Consumers
Power
Company

MIDLAND PROJECT - ALAB-106 MONTHLY REPORT FOR FEBRUARY 1982
DOCKET NOS 50-329 AND 50-330
FILE: 0.4.6 SERIAL: 16145

In accordance with Condition of Memorandum and Order ALAB-106, dated March 26, 1973, and Amendment No 1 of the Midland Plant Construction Permit, enclosed are ten copies of the following documents written or closed during the month: Bechtel Nonconformance Reports; sheets from the Bechtel Nonconformance Report Log; Bechtel Quality Action Requests; Bechtel Management Corrective Action Reports; Bechtel Quality Assurance Findings; Bechtel FLAGS Quality Action Requests; Babcock & Wilcox Reports of Nonconformity; Babcock & Wilcox In-Service Inspection Nonconformance Reports; Consumers Power Company Nonconformance Reports; Audit Finding Reports; Quality Action Requests; Corrective Action Reports; and Management Corrective Action Reports.

ORIGINAL

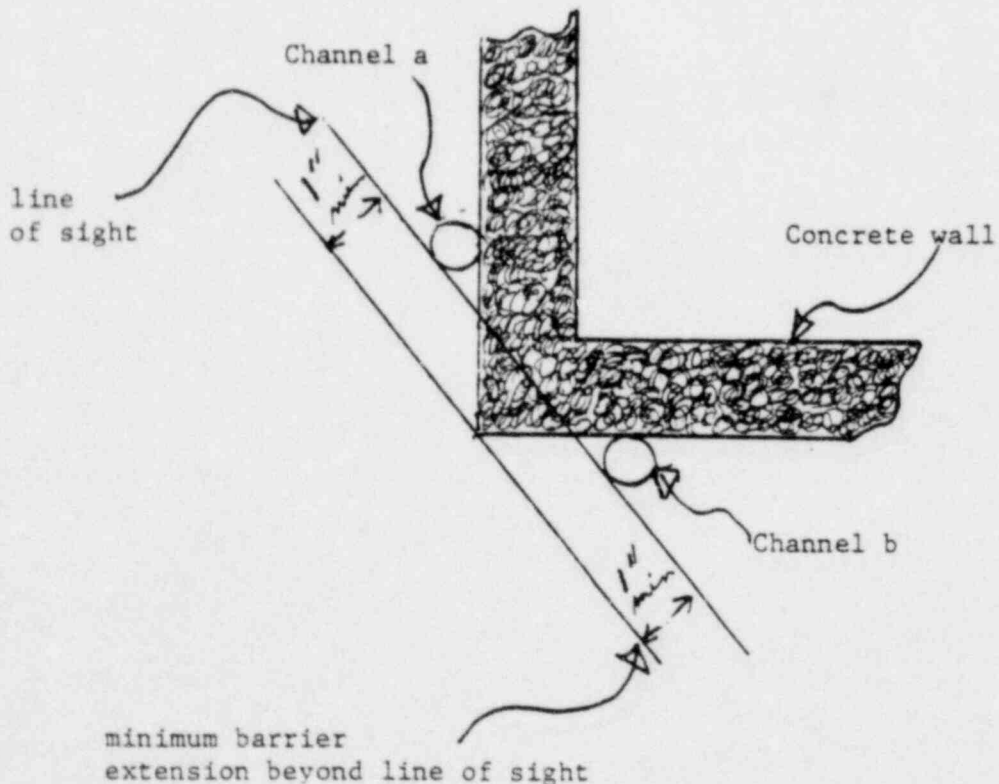
4. Section 3.3 $\sqrt{15.63}$ needs to be changed to $\sqrt{15.63 \Delta}$.
5. In 7.2 of Appendix A page A-13, second paragraph, the example indicates no torsion on L_3 . Deflection of L_1 would pull L_2 basically in the X direction placing torsion on L_3 unless L_1 and L_2 are so plastic that no moment is transmitted.
6. In Appendix B page B-1, the first example in 1) shows (line of sight added to sketch)

However, to have a barrier extending 1" beyond the line of sight per this specification, the sketch needs to show the wall extending 1" beyond the line of sight eg.:

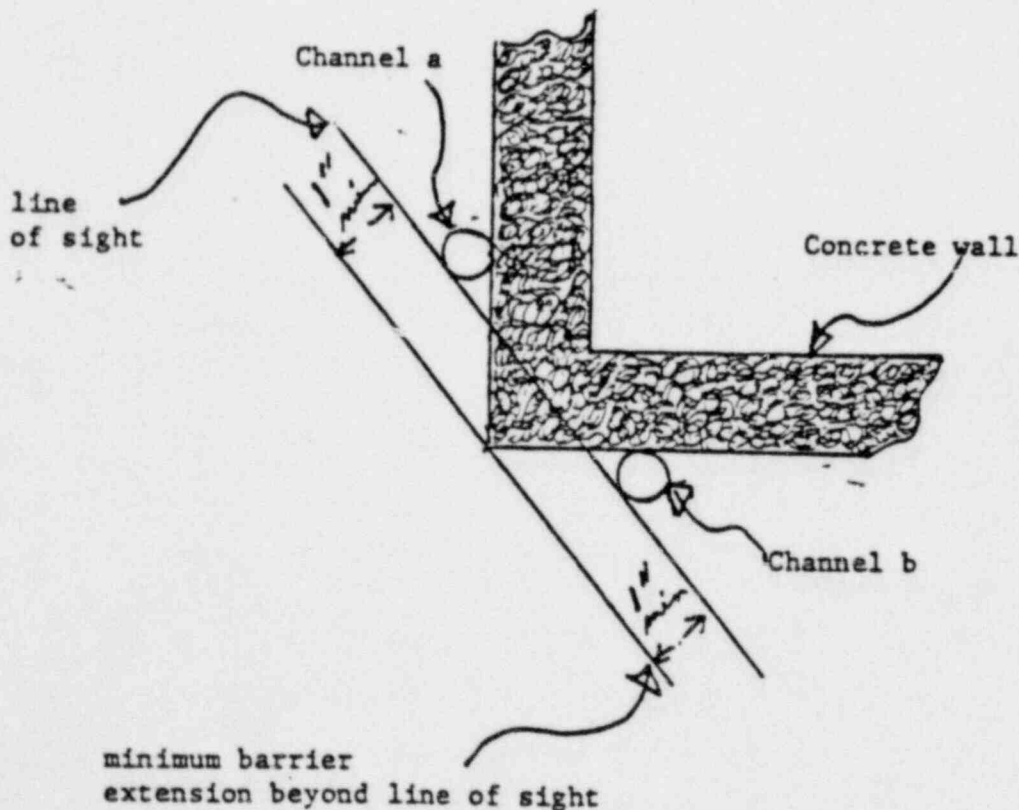
4. Section 3.3 $\sqrt{15.63}$ needs to be changed to $\sqrt{15.63\Delta}$.
5. In 7.2 of Appendix A page A-13, second paragraph, the example indicates no torsion on L_3 . Deflection of L_1 would pull L_2 basically in the X direction placing torsion on L_3 unless L_1 and L_2 are so plastic that no moment is transmitted.
6. In Appendix B page B-1, the first example in 1) shows (line of sight added to sketch)

However, to have a barrier extending 1" beyond the line of sight per this specification, the sketch needs to show the wall extending 1" beyond the line of sight eg.:

Reply:		⑨	
This is project engineering's partial response (see attached page).			
Signature: R.C. Hall for L.H. Curtis		⑩ Date: 11/16/81	
Action Verified:		⑪ Date: ⑫

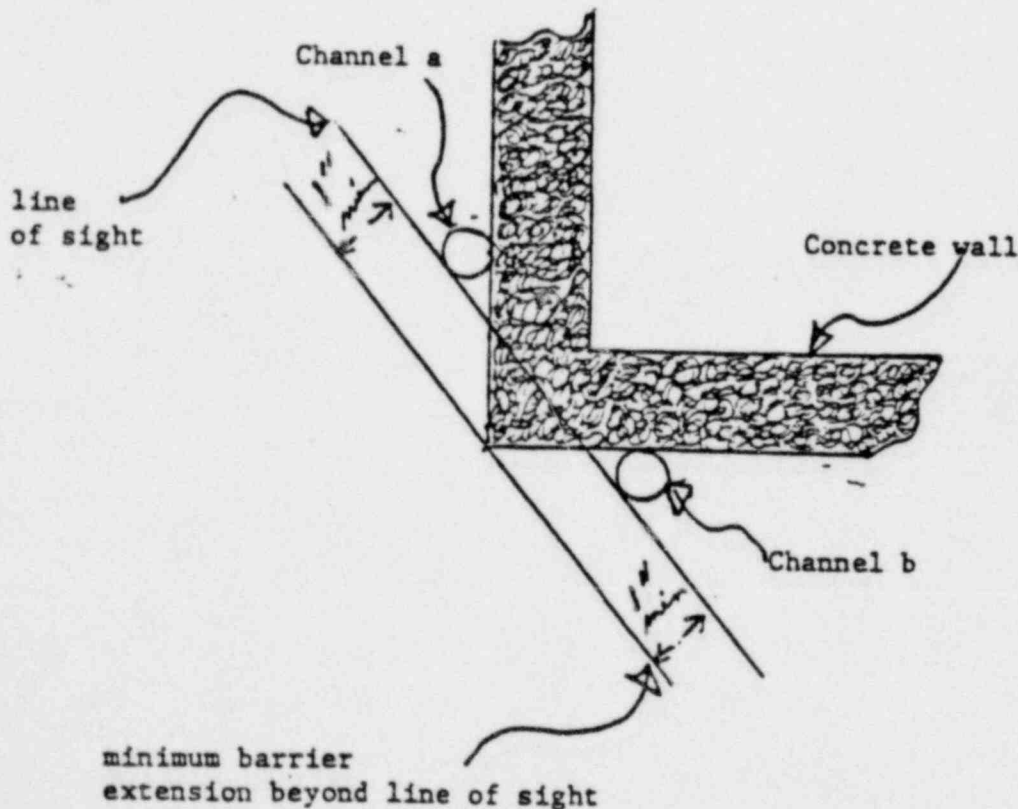
4. Section 3.3 $\sqrt{15.63}$ needs to be changed to $\sqrt{15.63\Delta}$.
5. In 7.2 of Appendix A page A-13, second paragraph, the example indicates no torsion on L_3 . Deflection of L_1 would pull L_2 basically in the X direction placing torsion on L_3 unless L_1 and L_2 are so plastic that no moment is transmitted.
6. In Appendix B page B-1, the first example in 1) shows (line of sight added to sketch)

However, to have a barrier extending 1" beyond the line of sight per this specification, the sketch needs to show the wall extending 1" beyond the line of sight eg.:

This is project engineering's complete response.
